**TOWN OF NEWBURGH  
PLANNING BOARD  
TECHNICAL REVIEW COMMENTS**

**PROJECT: GARDNER RIDGE**  
**PROJECT NO.: 2002-29**  
**PROJECT LOCATION: SECTION 75, BLOCK 1, LOT 4.12**  
**REVIEW DATE: 1 MARCH 2016**  
**MEETING DATE: 3 MARCH 2016**  
**PROJECT REPRESENTATIVE: TOM OLLEY AND DARREN DOCE, P.E.**

ROAD PROFILES  
**GARDNER RIDGE  
ROUTE 32**  
TOWN OF NEWBURGH, ORANGE COUNTY, NY

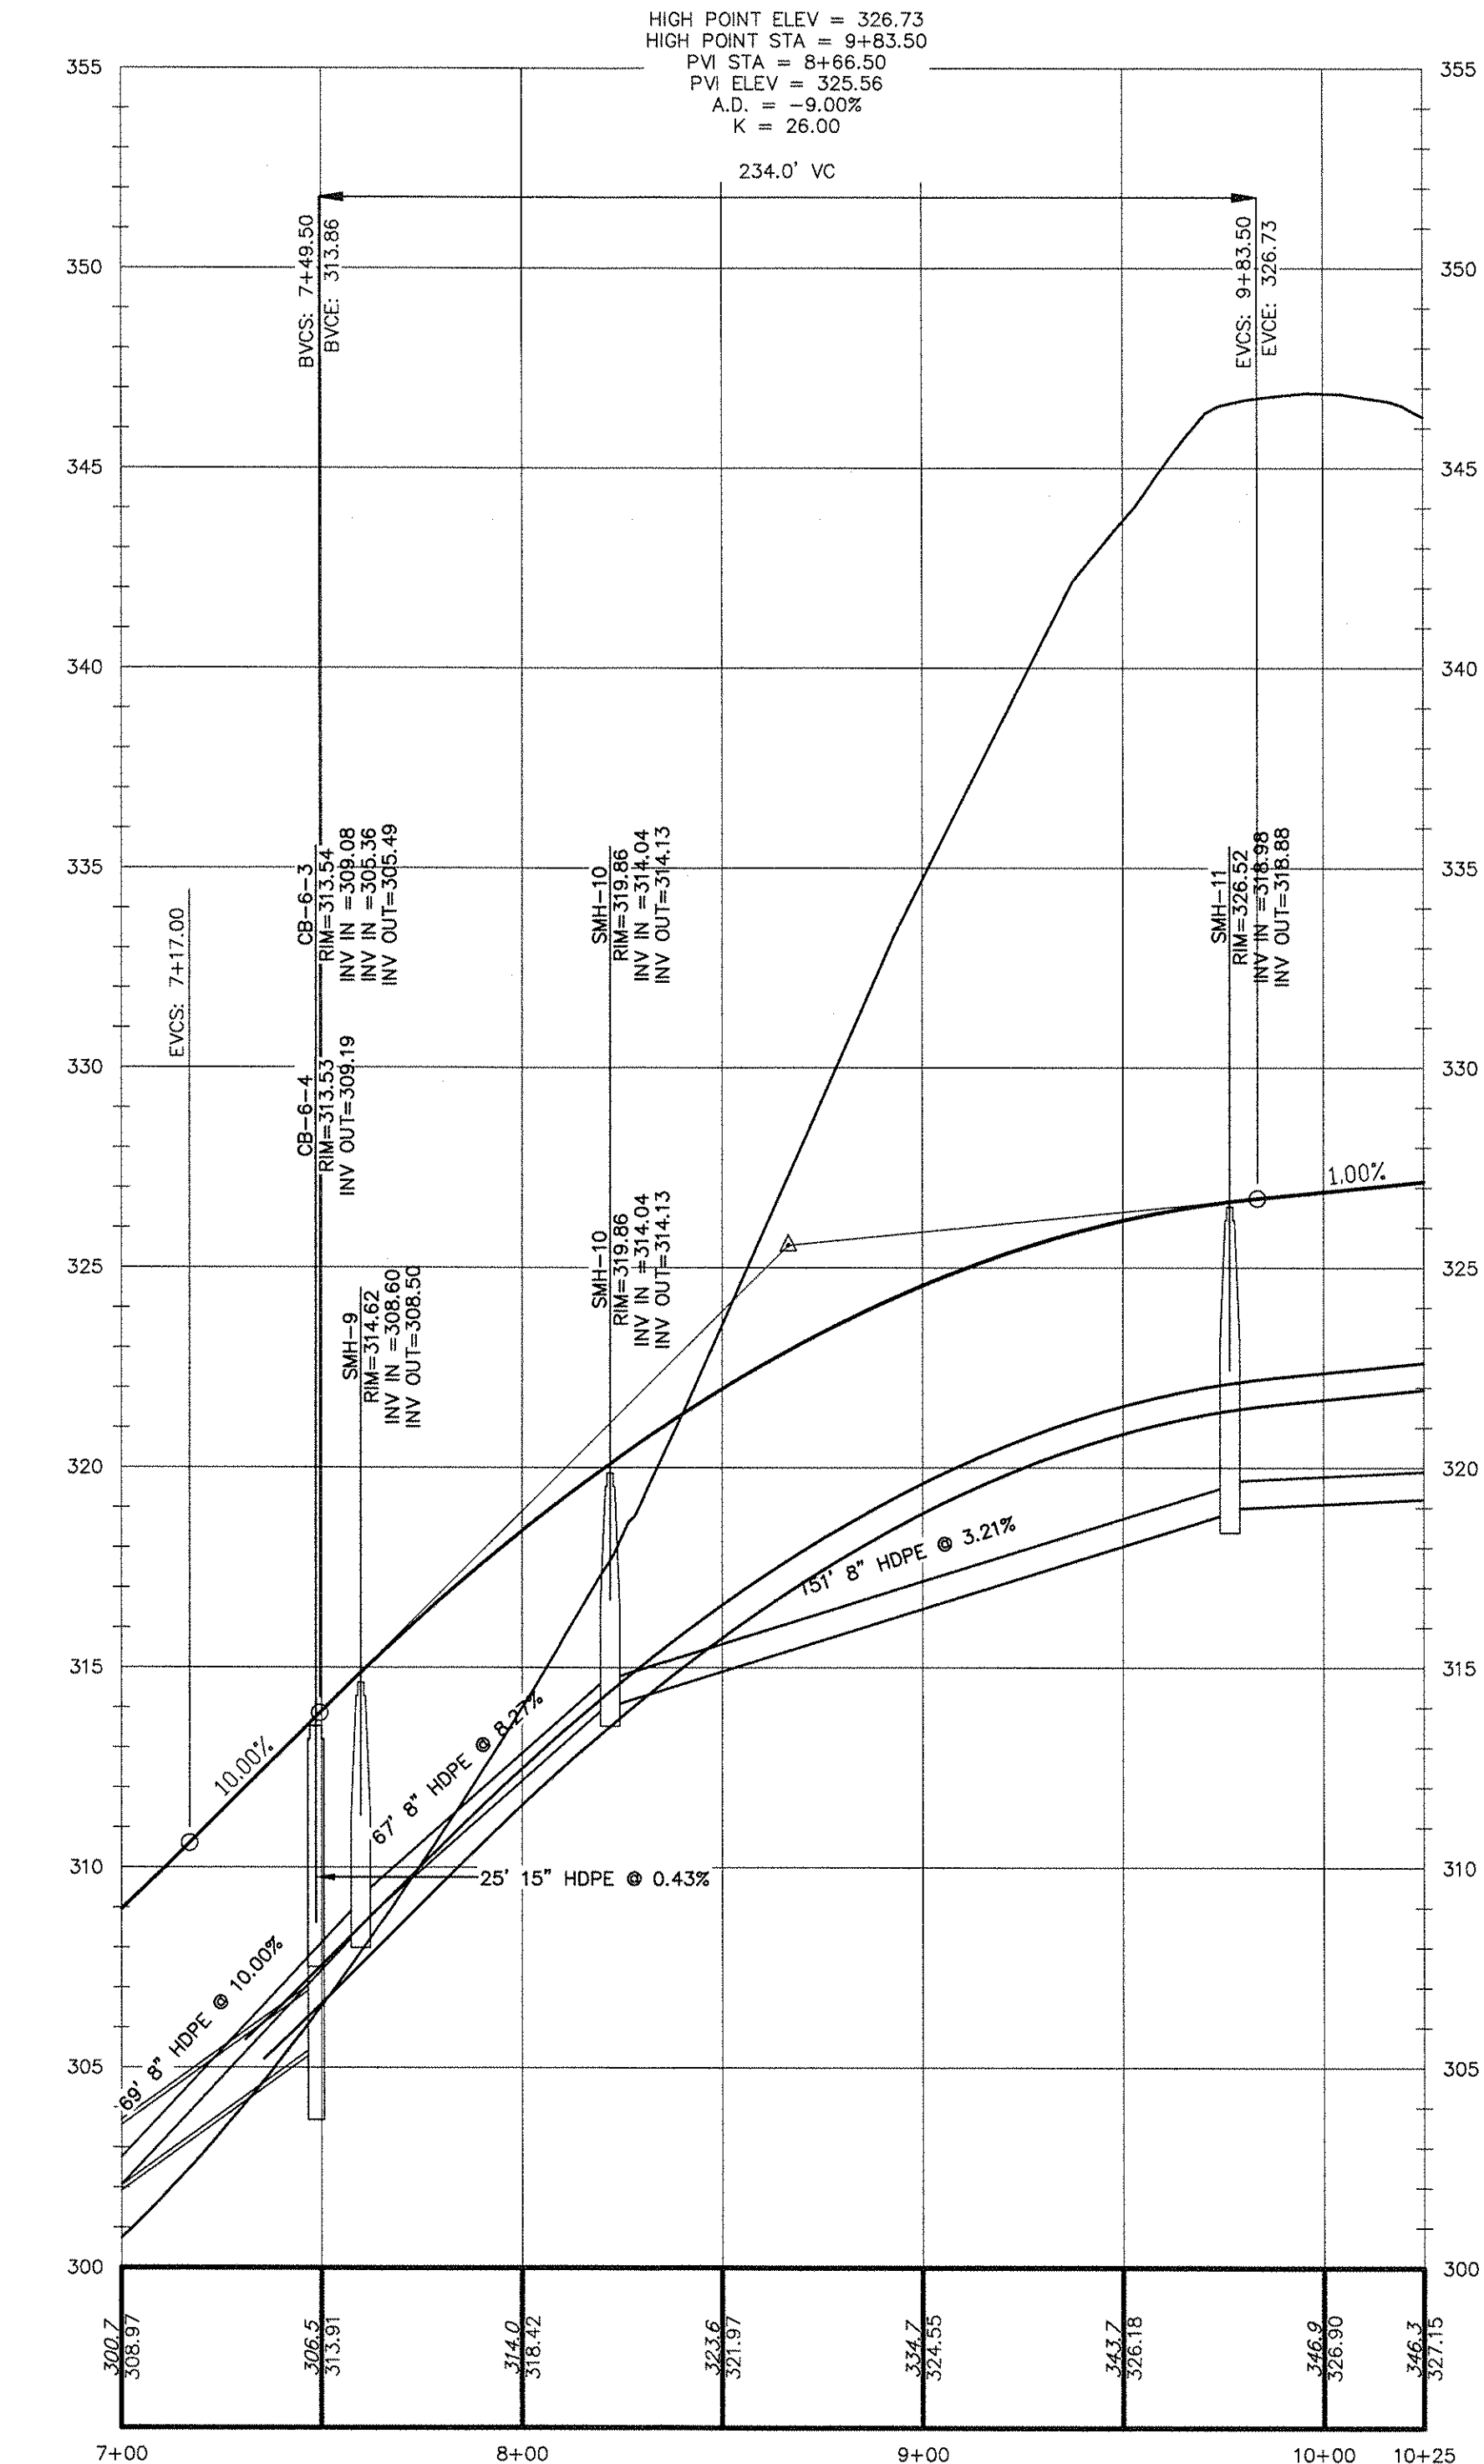
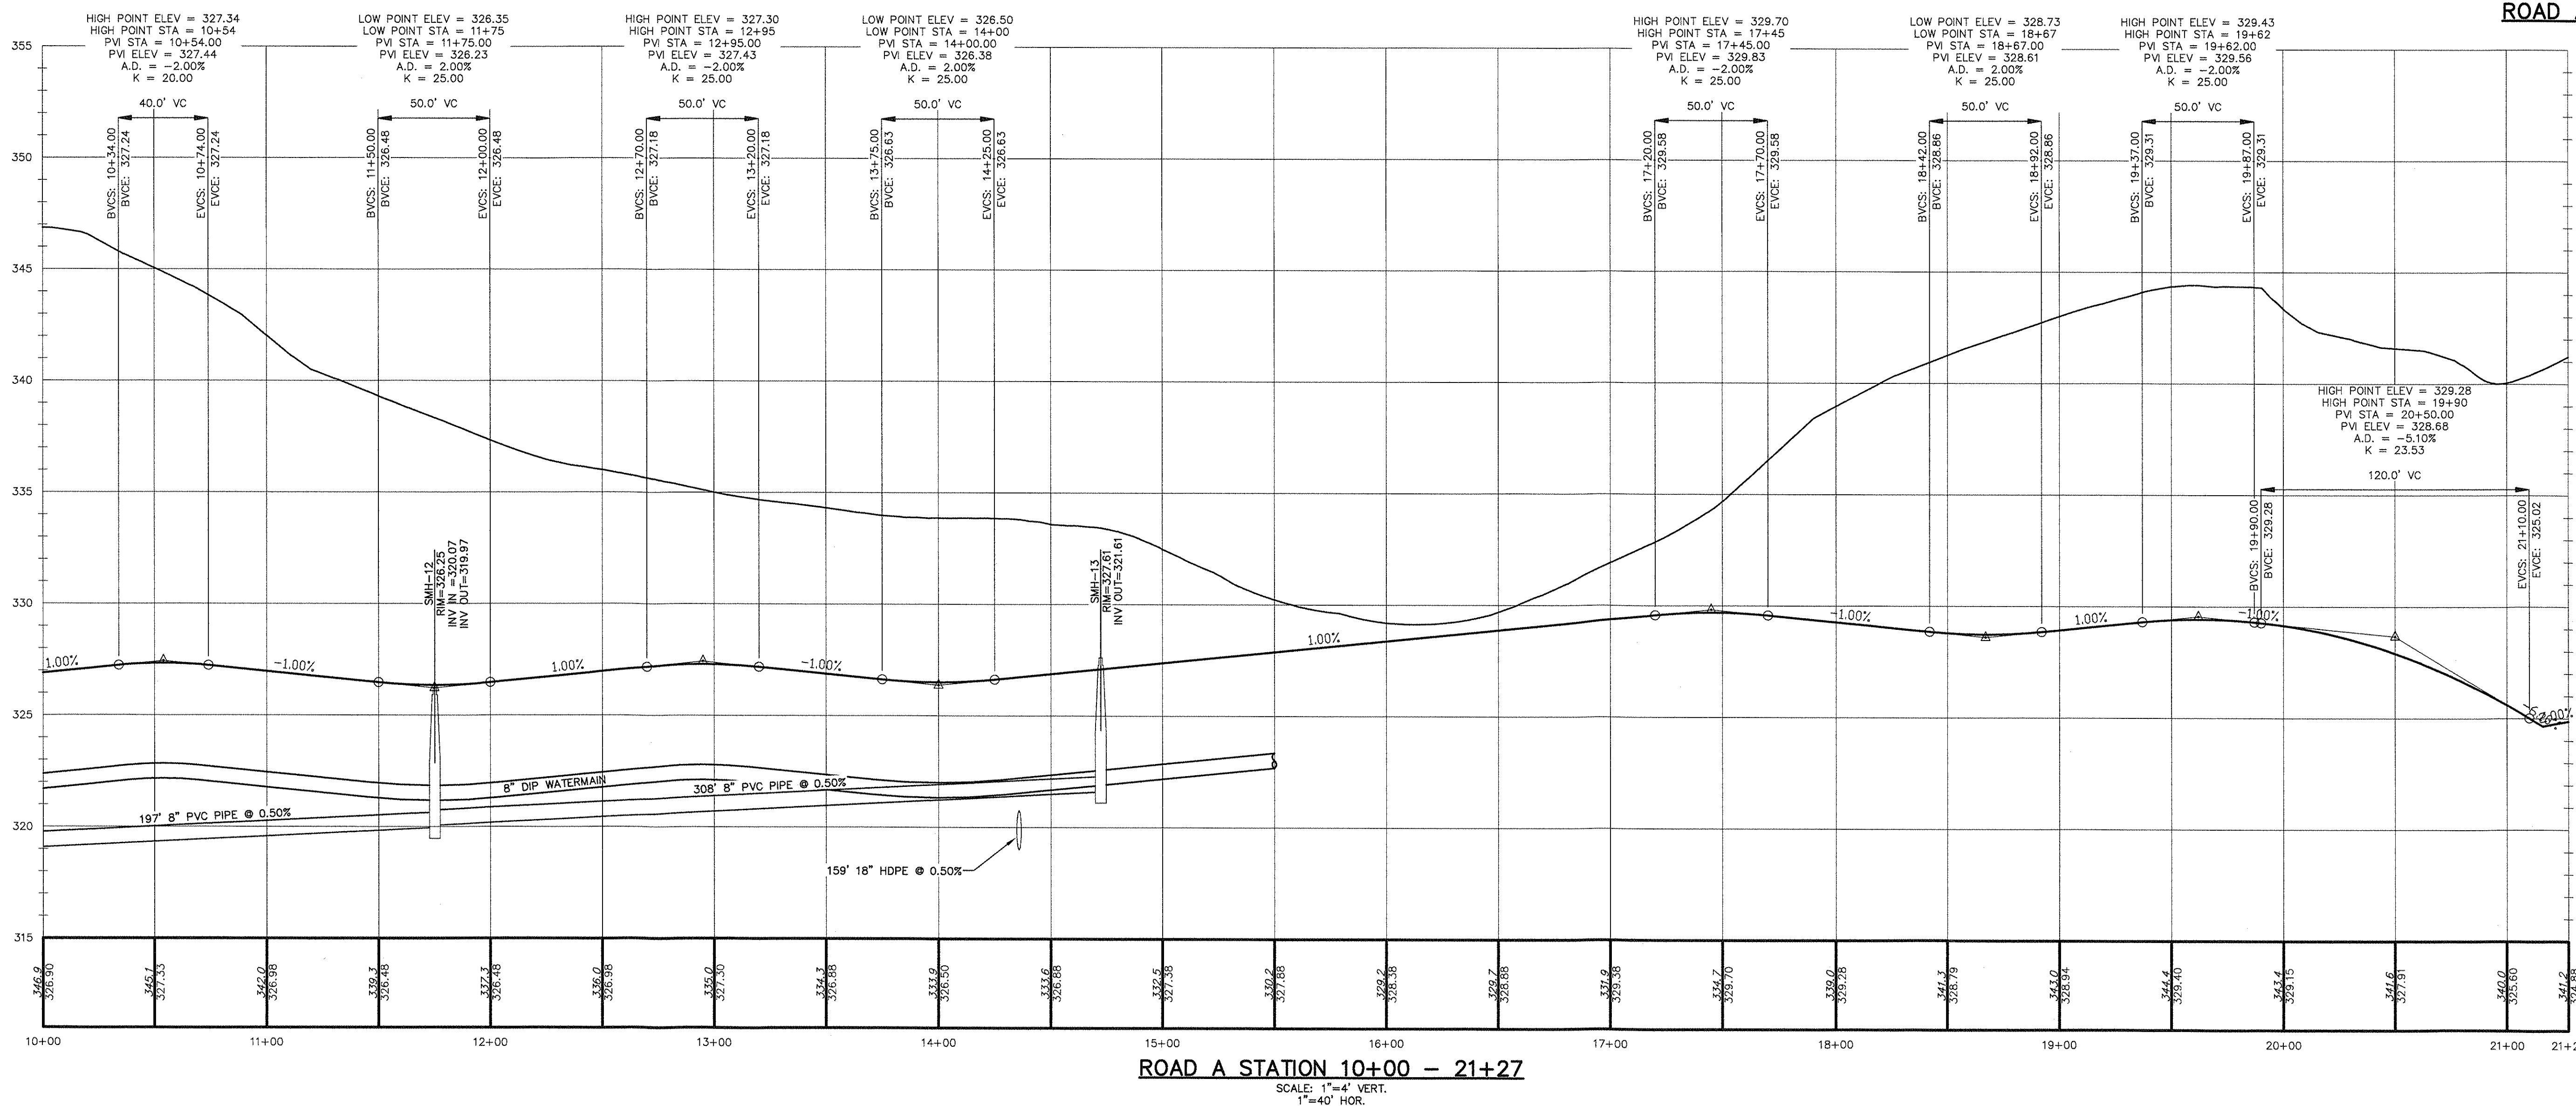
15. Future submissions must address on site landscaping.
16. Road profiles for Emergency Access Roads should contain design information regarding vertical curve data. Stormwater Management for discharge down the Emergency Access Road must be addressed. Pipe size at Emergency Access Road connection with Town Roads should be depicted along with inverts.
